Technical design note

Project name	Dunsbury Park - Plot 5		
Design note title	Reserved Matters - drainage condition response		
Document reference	19453-HYD-XX-XX-RP-C-0003		
Author	Alastair Todd		
Revision	P01		
Date	2 August 2023	Approved	☐

This technical note looks to discharge drainage conditions in relation to Reserved Matters application for Phase 1 Plot 5 of APP/17/O1324. This report sets out each condition as worded by Hampshire Lead Local Flood Authority and addressed accordingly.

SCALE @ A1
1:200

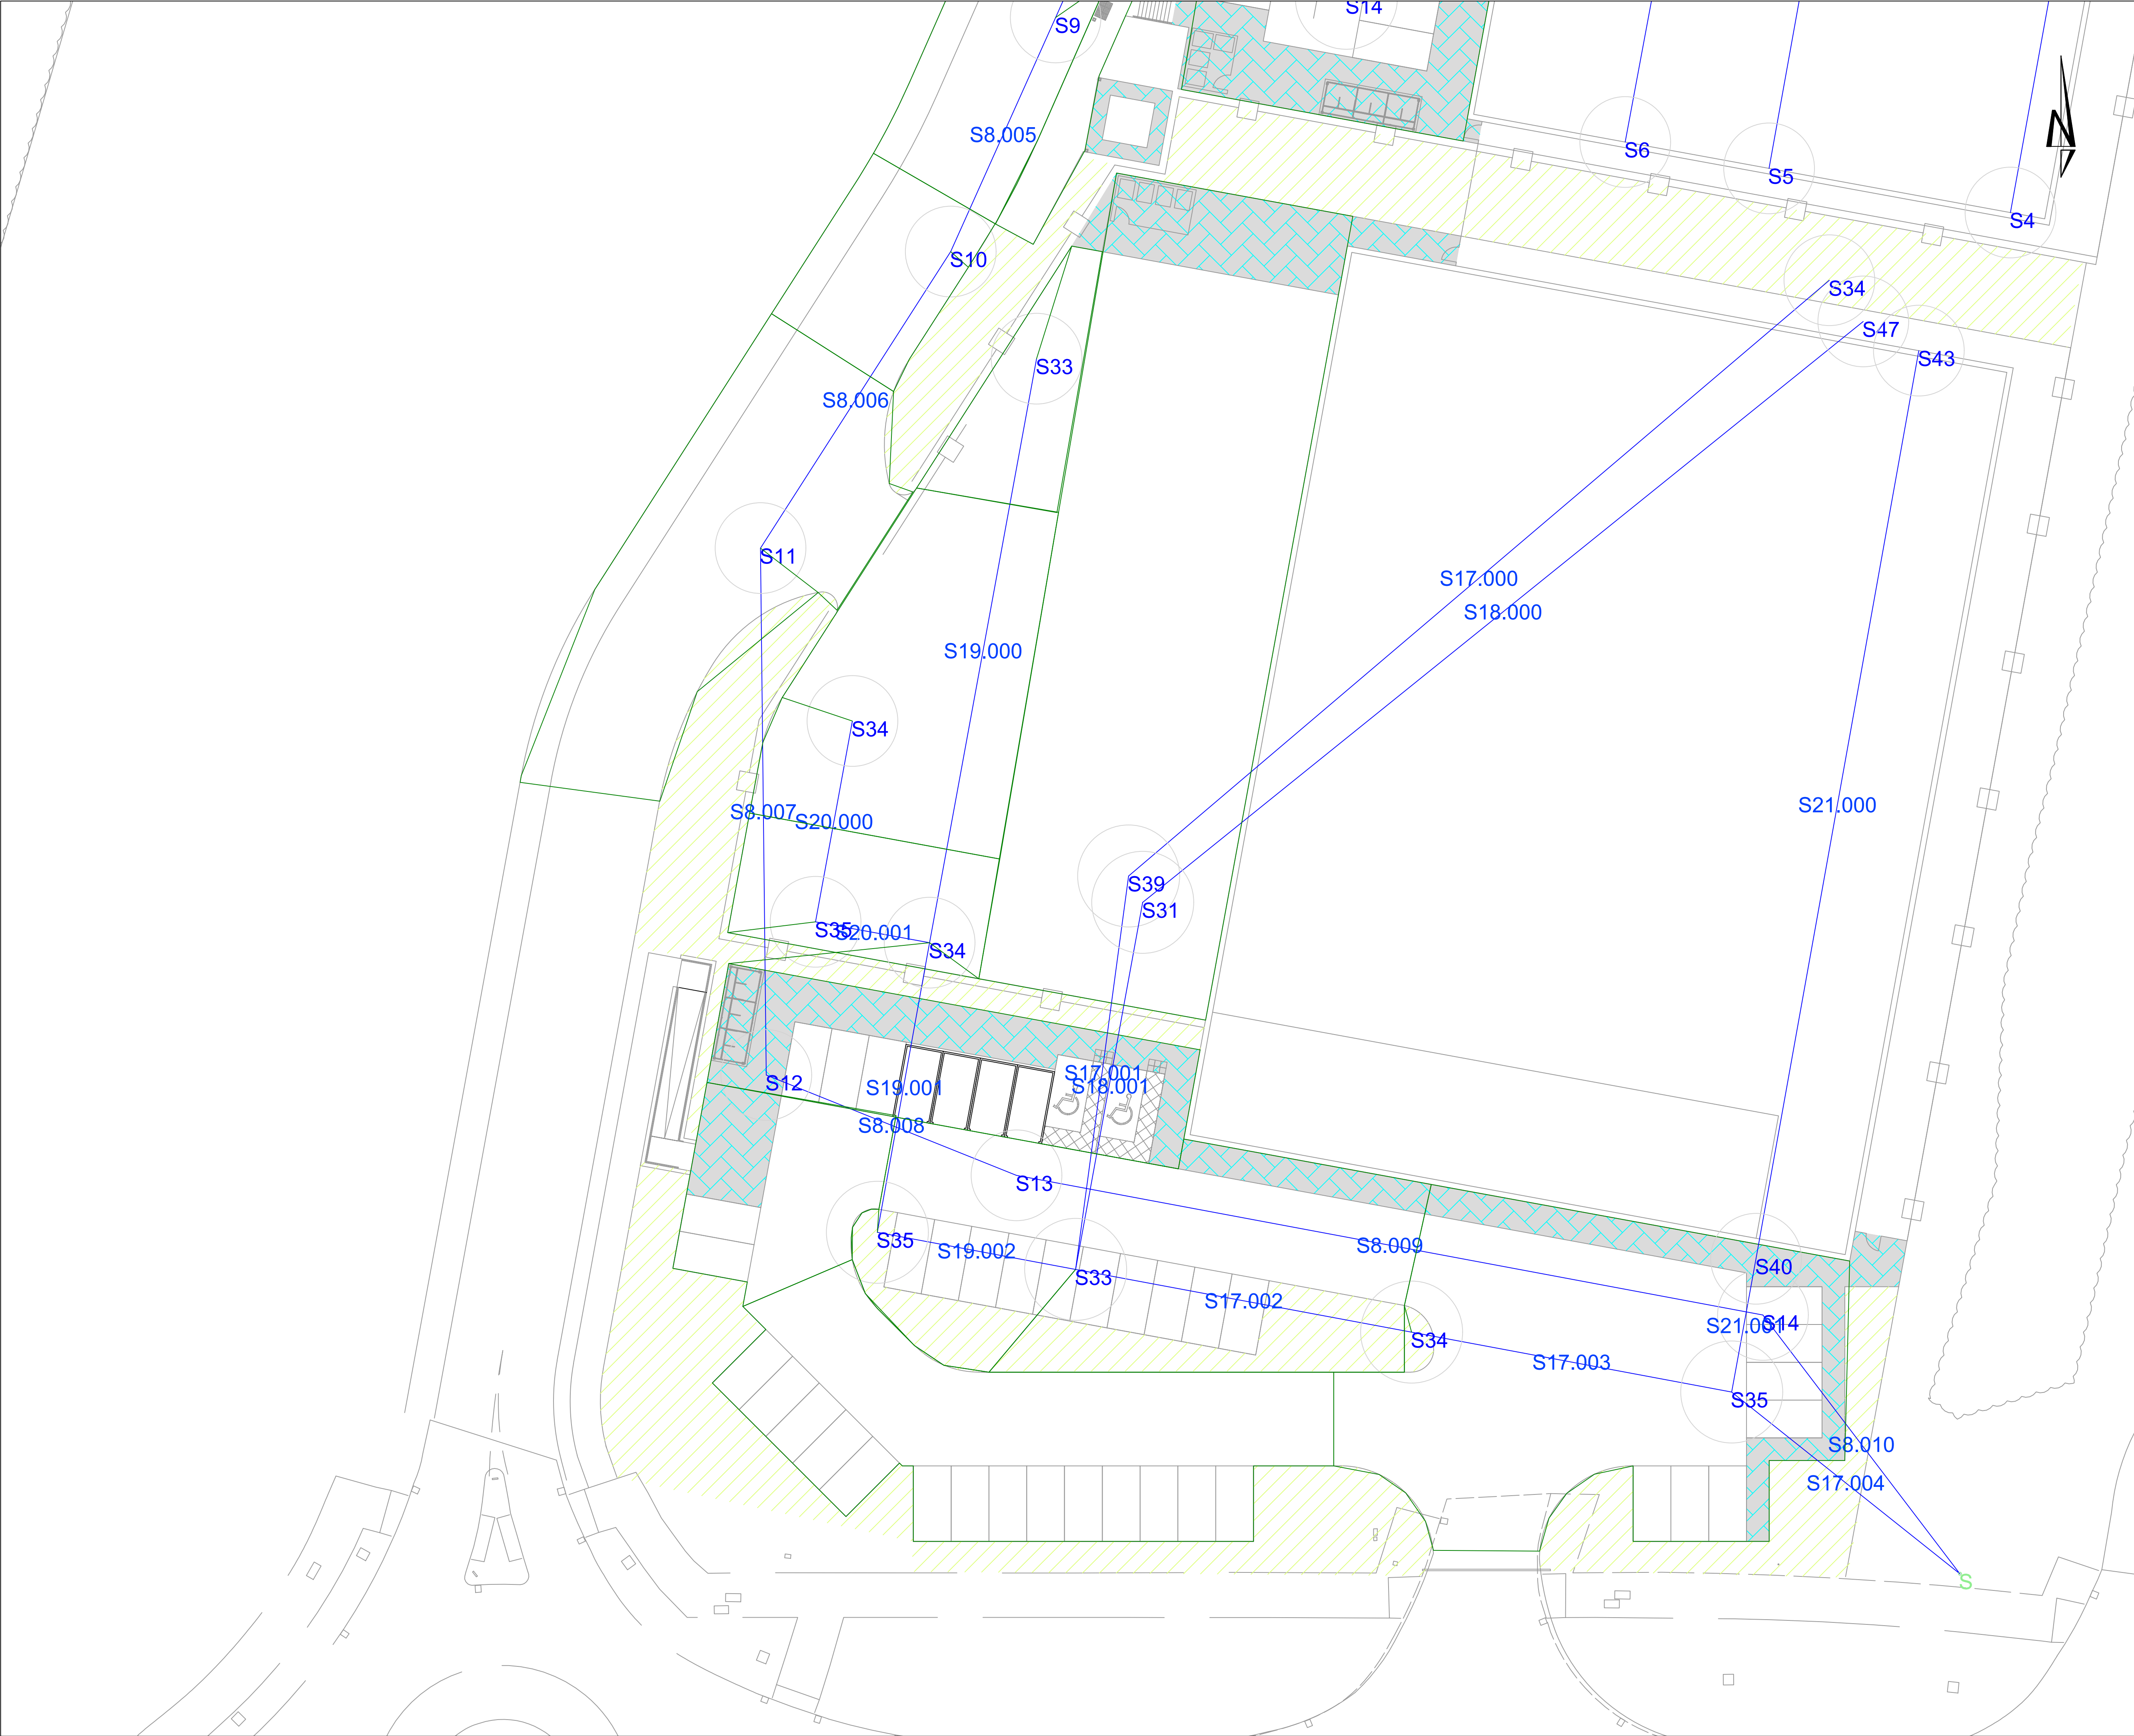
2. Confirmation that flooding modelled during the 1 in 100 year storm event does not occur for the 1 in 30 year event.

3. Clarification over discrepancies between the calculations and drainage layout, especially with regards to the flow control discharge rates.

A new set of modelling has been undertaken to align with contractor requirements, primarily the inclusion of siphonic drainage for the unit roofs. These calculations and pipe layout are included in **Appendix C** and show that no flooding occurs on site in the 1 in 30 year storm event. Any flooding occurring in the 1 in 100 plus climate change event is designed to be retained within car parking areas and diverted away from critical infrastructure.

It should be noted that impermeable areas shown on calculations do not match those shown in Table 1 due to the exclusion of roof areas served by siphonic drainage. Siphonic drainage modelling requires for a discharge rate to be inputted rather than an area attributed to a certain pipe within the network.

The site drawings as shown in **Appendix B** and the pipe layout drawing shown in **Appendix C** show that there are no discrepancies between proposed discharge rates and those modelled.
